**ZONNEQUA WIND FARM GRID CONNECTION (KLEINSEE, NORTHERN CAPE):  
APPLICATION FOR AMENDMENT OF THE ENVIRONMENTAL AUTHORISATION  
AVIAN SPECIALIST COMMENT – 2021**

## **1. Introduction**

**Figure 1:** The change in the proposed 132 kV grid connections: (i) corridor width (300m to 600 m) to the Gromis substation (top), and (ii) the increased size of the corridor into the Gromis substation.

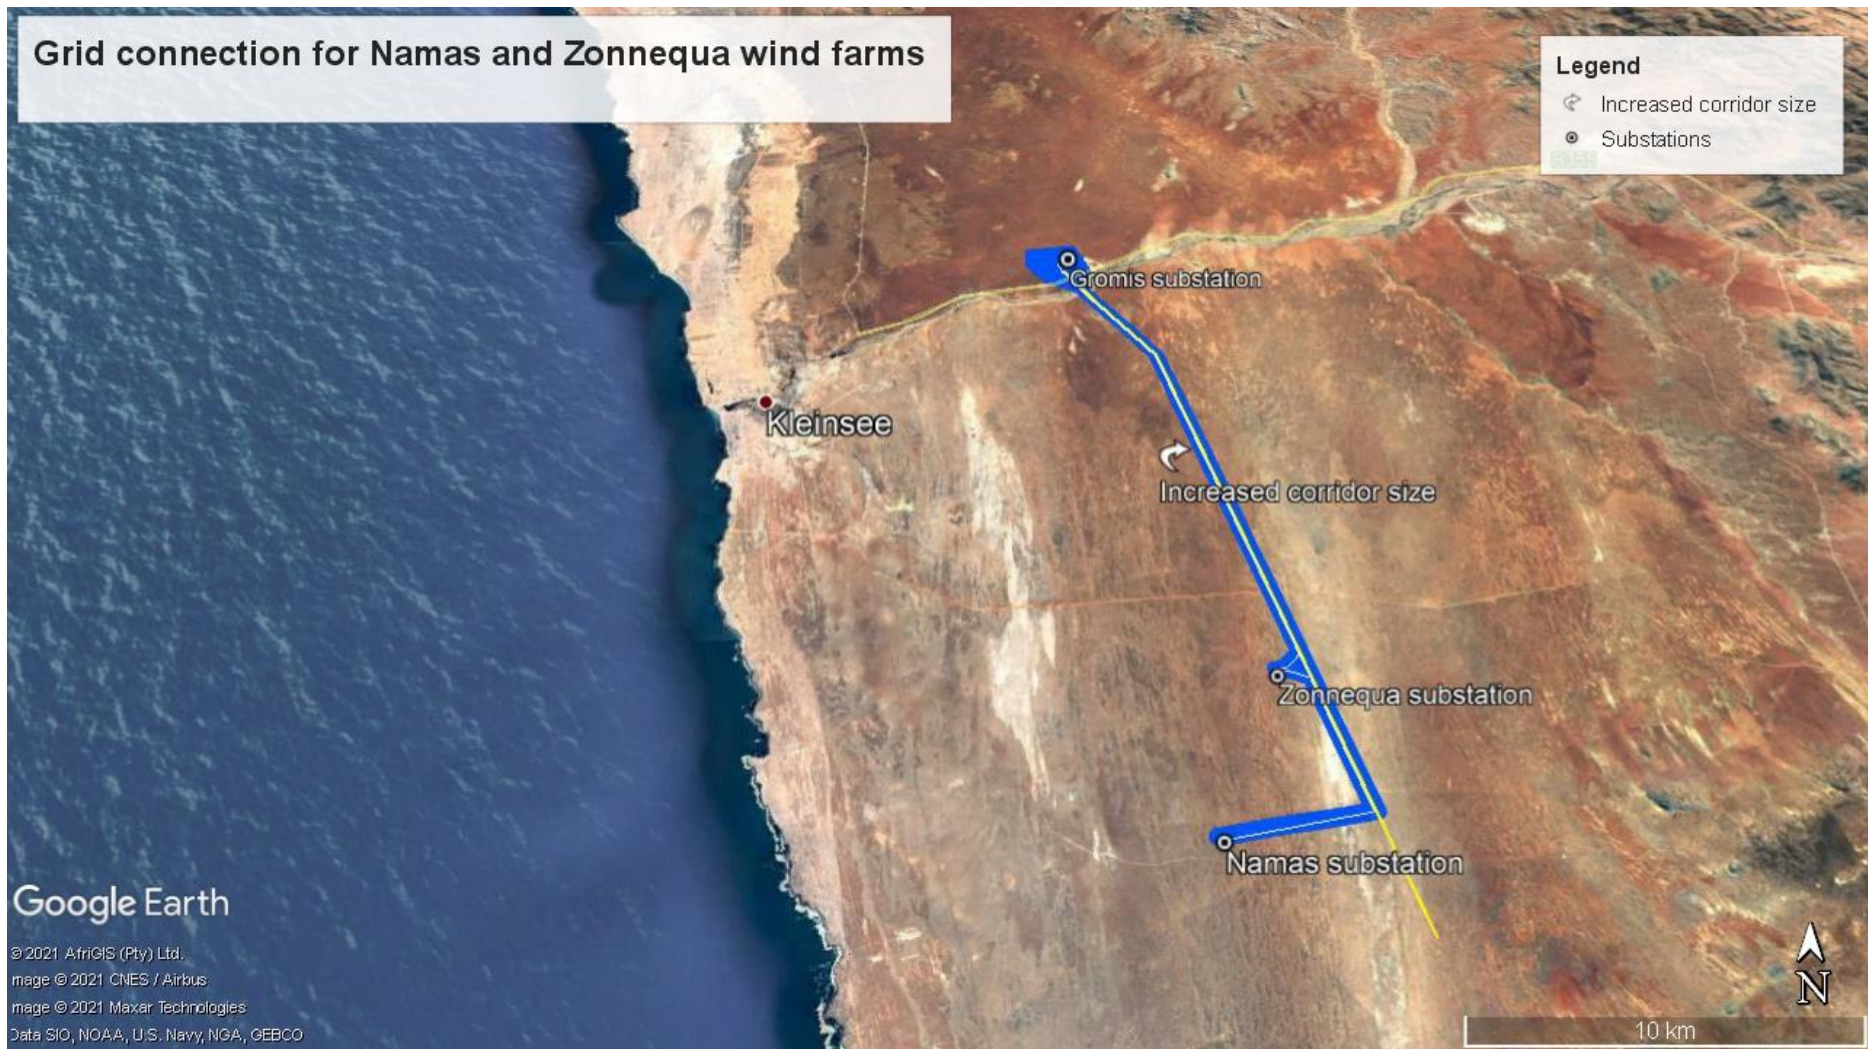
The new amendment proposes that the width of the approved corridor increases from 300m to 600m in width for the length of line from the Gromis substation to the Zonnequa on-site substation (blue in Figure 1). Given that the power line exporting the energy from the two wind farms will still lie adjacent, and the pylons staggered, to the proposed 400 kV line, the risk to birds, particularly the collision-prone bustards will not change. This is because the alignment next to the proposed 400 kV line will remain (whatever side it is placed – east or west) and that provides increased visibility of the two lines from the staggered pylon effect and the addition of bird diverters to both lines will increase visibility, and decrease avian risks, further.

The habitat immediately to the north of the Gromis substation is highly altered and compromised by mining activities and, as such, holds no importance to the local avifauna. Thus, the widening of the corridor to accommodate a line from the north will not impact the impact to the avifauna in the area.
